Groundwater Application Review Summary Form

Application # G- 19148

PUBLIC INTEREST REVIEW FOR GROUNDWATER APPLICATIONS

TO: Water Rights Section Date 6/30/2023
 FROM: Groundwater Section Joe Kemper
 Reviewer's Name
 SUBJECT: Application G- 19148 Supersedes review of 11/30/2021
 Date of Review(s)

Water-Level Measurements in Nearby Wells – red box covers wells shown in second hydrograph

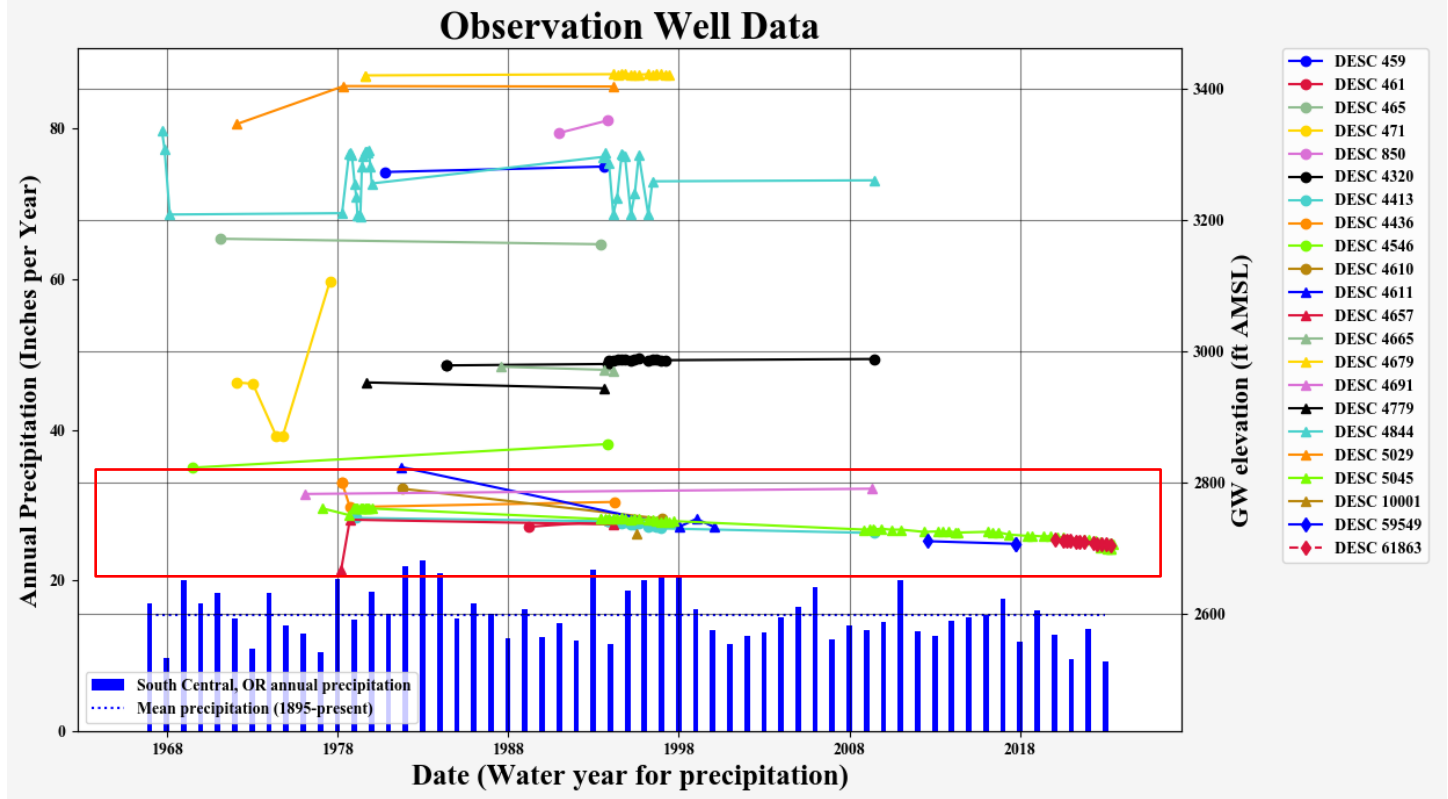
- B3. **Groundwater availability remarks:** The applicant's proposed POA is located in an area of the Deschutes Basin aquifer system that represents a transition across the Sisters Fault Zone, which transects the Deschutes Basin from the northeast to the southwest. Water levels to the southwest (up-gradient) of the SFZ tend to be shallower than to the northeast and typically show long-term trends that reflect short- and mid-term climate cycles. The SFZ acts as a narrow, low-permeable zone where potentiometric head is higher up-gradient and decreases down-gradient. Water levels are much deeper to the northeast of the SFZ and, away from the SFZ, water level trends often show long-term declines that have been attributed to lack of natural and artificial recharge as well as increased groundwater pumping (Gannett et al., 2017). The only available water level measurement from the applicant's well falls within the elevation range of wells that are downgradient of the low-permeability SFZ and show continual year-on-year declines since the mid-1990s. Notably, DESC 5045 has declined more than 50 feet since 1979, which is considered to have declined excessively as per OAR 690-008. Water levels in this area declined approximately 1 ft/yr from 1995 to 2019. Those declines have doubled to approximately 2 ft/yr from 2019-2023 (see DESC 5045 and DESC 61863). **Because the target aquifer has seen excessive declines, the target aquifer is considered over-appropriated in this area. Because pumping has been shown to exacerbate these observed declines, the proposed use is determined to be not within the capacity of the resource.** If the permit is issued, the conditions listed in B1(d) are strongly recommended.

- i. ☒ The permit should contain condition #(s) 7N (Annual SWL); Medium Water-Use Reporting ;
 - ii. ☐ The permit should be conditioned as indicated in item 2 below.
